425 FAIRVIEW AVENUE

RECOMMENDATION MEETING WEST DESIGN REVIEW BOARD MEETING 07.15.2015 | 14-004 | DPD #3017804

MID RISE PLAN

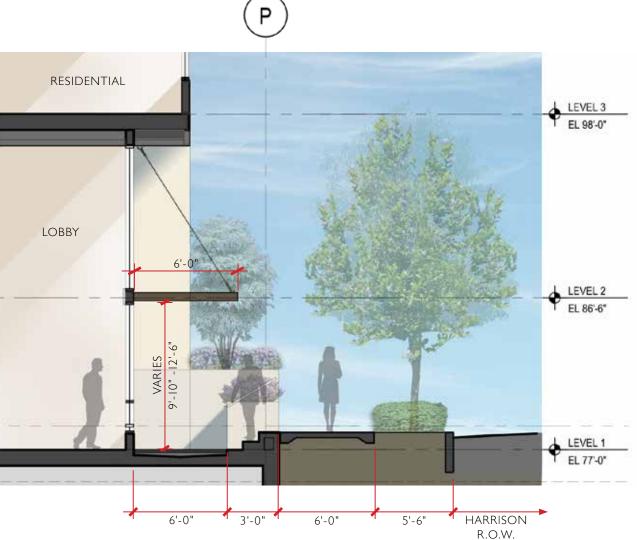
- Design the residential stoops to be effective. (PL3.A.4, PL3.B.2)
- Provide enough space to provide security, and a sheltered transition at the residential stoops. (PL3.A.4, PL3.B.2)

PENTHOUSE DEVELOPMENT

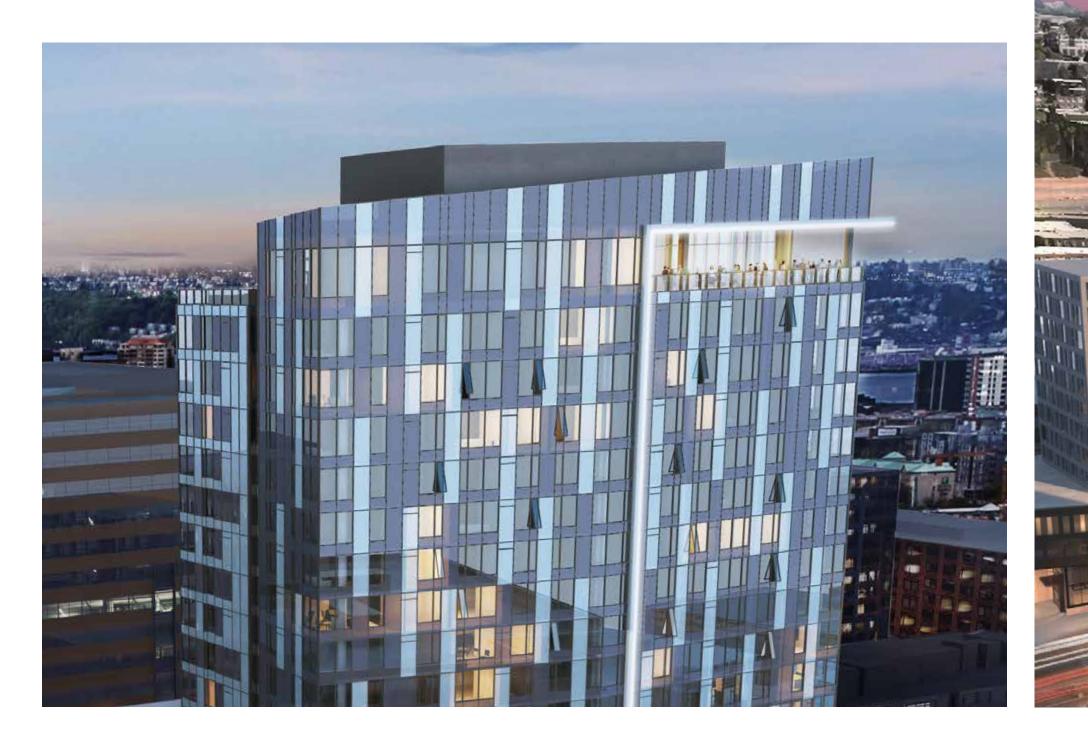
CONSIDER A BIGGER SETBACK AND VARIED ROOF LINE OF THE TOWER AND PENTHOUSE. (CS2.II.II, DC2.A.2, DC2.I.I)

HIGH RISE PLAN

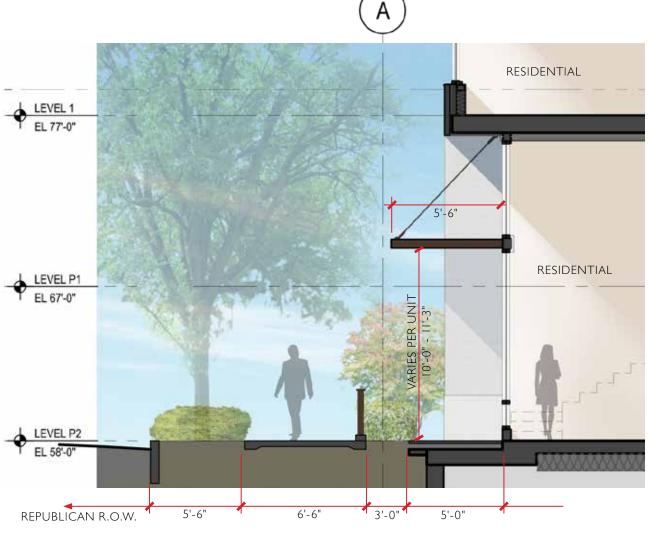
- Design the residential stoops to be effective. (PL3.A.4, PL3.B.2)
- Provide enough space to provide security, and a sheltered transition at the residential stoops. (PL3.A.4, PL3.B.2)

FAIRVIEW PLAN

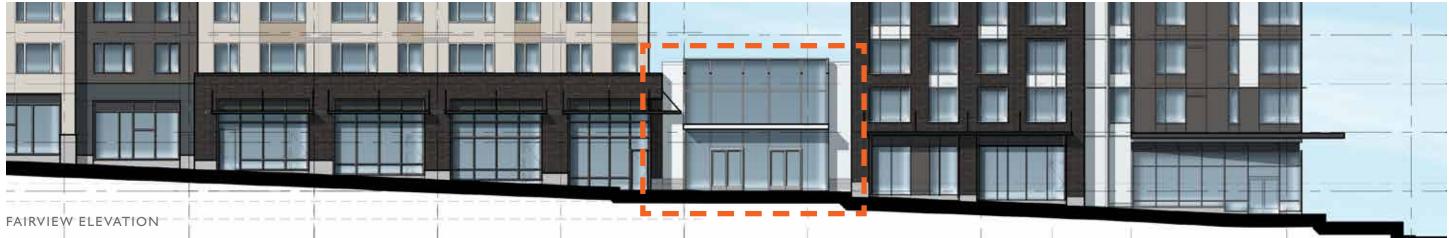
- Provide eddies, and porosity for public spaces. (CS2.B.2, PL2.I, DC2.I.i)
- All commercial space entries should be public and welcoming. (PL2.B.3, PL2.C.I, PL2.I, PL3.C.I)

DEPARTURE #1 - TOWER SETBACK ABOVE PODIUM

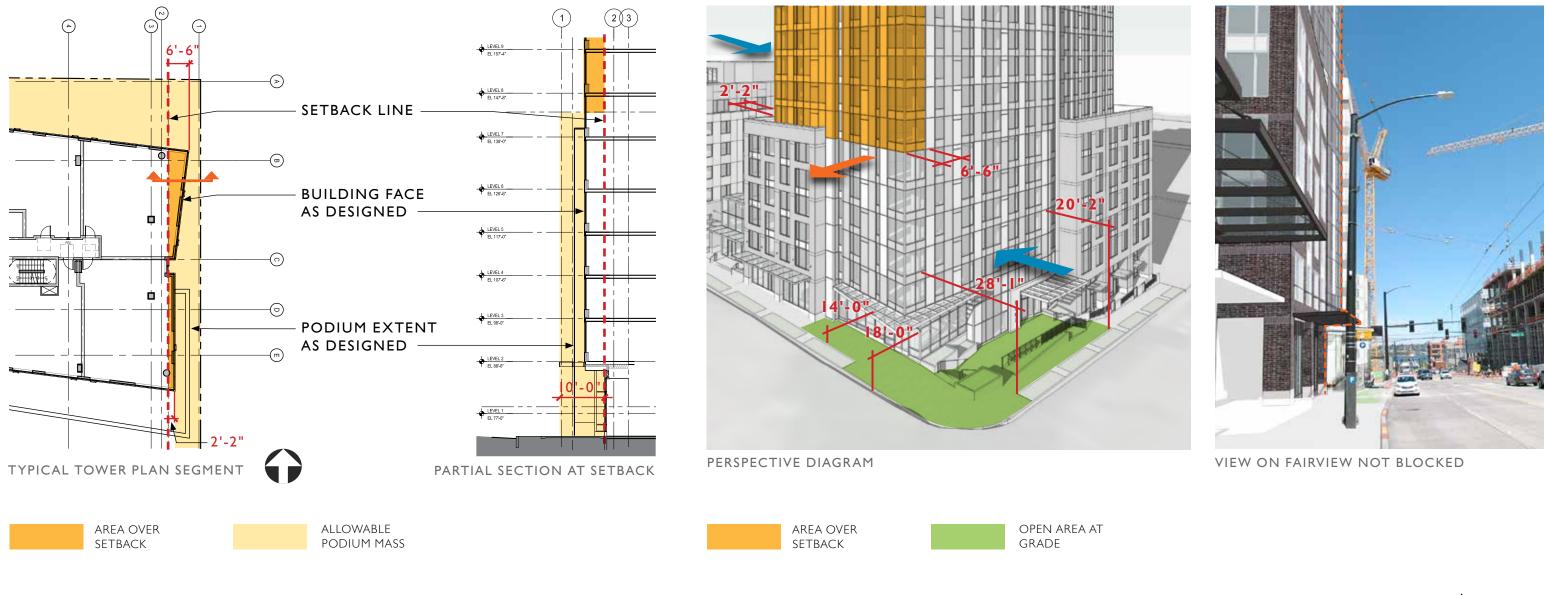
Portions of a structure along Fairview Ave N exceeding 65' shall be setback a minimum depth of 10 feet.

To provide more open space between structures and at grade portions of the tower do not meet the 23.48.013.C setback. The south half of the tower is 2'-2" over the set back, and the northern half taper's from 2'-0" to 6'-6" over the setback.

The departure request is only for portions of the building above the podium (65'+) as the base of the tower is within the zoning requirements and holds the streets' edge as required. Extending past the setback and elongating the tower in the east / west direction allows the tower to be significantly narrower in the north / south direction. The slenderness allows for greater breathing room between buildings and allows for a large open space at the corner and along Republican St (CS2.B.3, CS2.D.I). The open space aligns with the open space across the street responding to the board's EDG comment "encourage a slender tower with more open space at the base (CS2.A.2, CS2.II)." The open space at the corner is between 14'-0" and 18'-0" plus additional width for landscaping and is between 20'-2" and 28'-1" plus landscaping along Republican creating a mini park-like environment in the public realm. Views on Fairview are not compromised by the tower. The tower is undercut at the base providing greater visibility at pedestrian level and adjacent projects' masses are similar in size and scale.

DEPARTURE #2 - enclose roof area setback

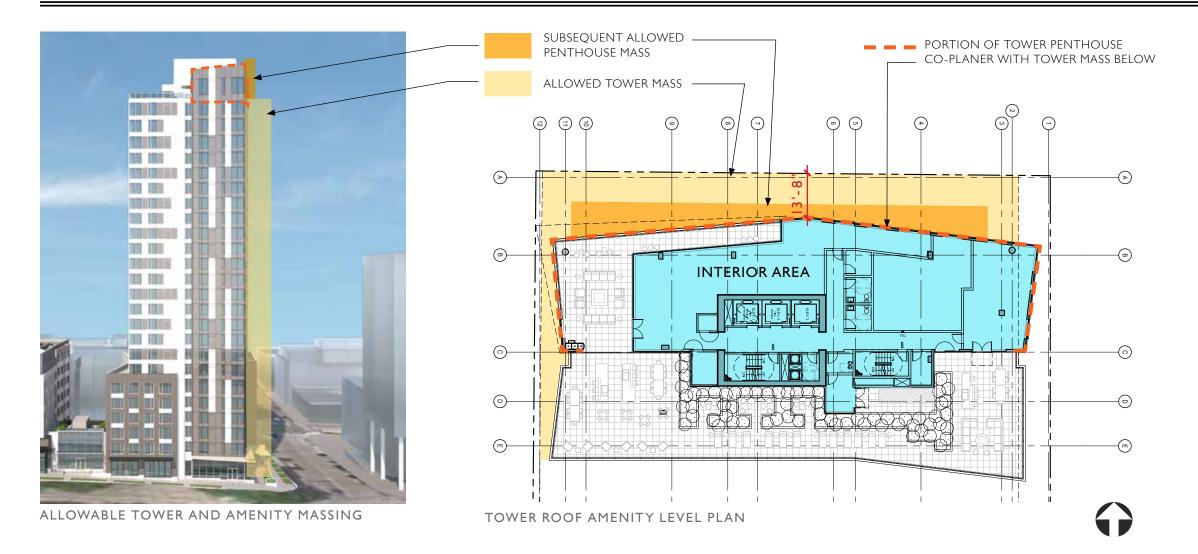
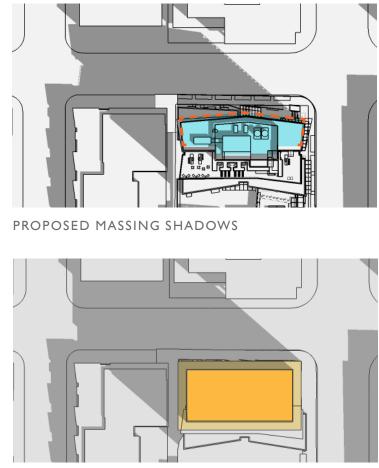
increased to 65% of the roof area, provided that all of the following are satisfied: A. All mechanical equipment is screened; and B. No rooftop features are located closer than 10 feet to the roof edge.

exceed the 65% coverage limit, portions of the roof facade are co-planar with the tower massing below and are not 10' away from the roof edge.

The majority of the co-planer facade is located on the north side of the tower. Instead of holding the amenity space back 10' from the roof edge at this face, the entire tower is held back 13'-8" or more from the north property line. As a result, the amenity space is more than 10' away from what would be a permitted roof edge. As such, the surrounding projects do not have increased shading from the amenity space in keeping with design guideline CSI. Furthermore, the roof line has been adjusted and a notched area provided to add scale and variety to the penthouse in response to the board's comment "Consider a bigger setback and varied roof line of the tower and penthouse. (CS2.II.II, DC2.A.2, DC2.I.I)" Because the site will be highly visible from busy Mercer Street to the north and the westward traffic on Republican St, the design should emphasize and celebrate the corner of Fairview Ave N and Republican St as it is a part of a regional transportation corridor (CS2). Having the additional height of the amenity space coplanar with the tower facade further slenderizes the tower and creates a statement with an appropriate urban scale and transition from high vehicular traffic on Fairview to slower, more pedestrian traffic on Republican (CS2.C.I).

DEPARTURE #3 - STEPPING SETBACK AT HARRISON

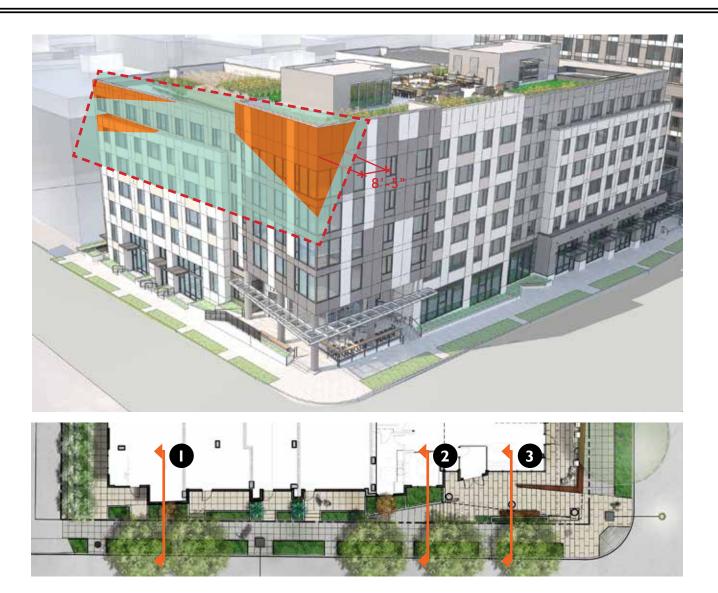
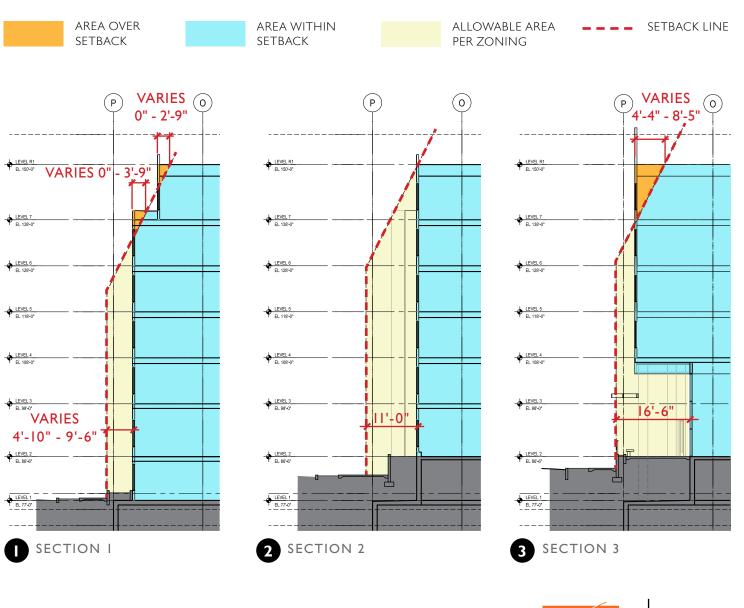
Any portion of a structure greater than 45 feet in height is required to set back from the lot line along Harrison St. A setback of one foot for every 2 additional feet of height is required, up to a maximum setback of 15 feet measured from the street lot line.

While the mid-rise building does setback along Harrison Street, it does not meet the specific setback requirements. To maintain the angled vernacular the building's encroachment tapers from 3'-9" over the setback at the western edge to none at all in the middle. The massing on the eastern edge sets 8'-4" over the setback and tapers towards the middle. RESPONSE

The massing of the mid-rise building is meant to relate to the angular massing of the tower as supported by the board ("The board members indicated they may grant this departure depending on how the proposed setback at this portion of the development will relate to the rest of the building design"). Along the majority of the Harrison St facade, the setback departure has been reduced from that originally proposed during EDG. At the east end however, the massing has been adjusted in response to the board's comment "Continue the evolution of the design highlighting the corners. (CS2.1.IV, CS2.C.1)". The revised design at the corner of Fairview and Harrison provides open space at grade in the pedestrian / public realm (CS2.B.3, PL1.A, PL2.C.3), while the added height better highlights the corner at an appropriate civic scale (CS2.C.3). The massing in this location sets 8'-5" over the setback maximum and tapers towards the middle where no departure is required. The angled setback provides a more dynamic facade and helps provide transition space at grade between residential units and the public sidewalk area as well as relief at the top level per design guideline
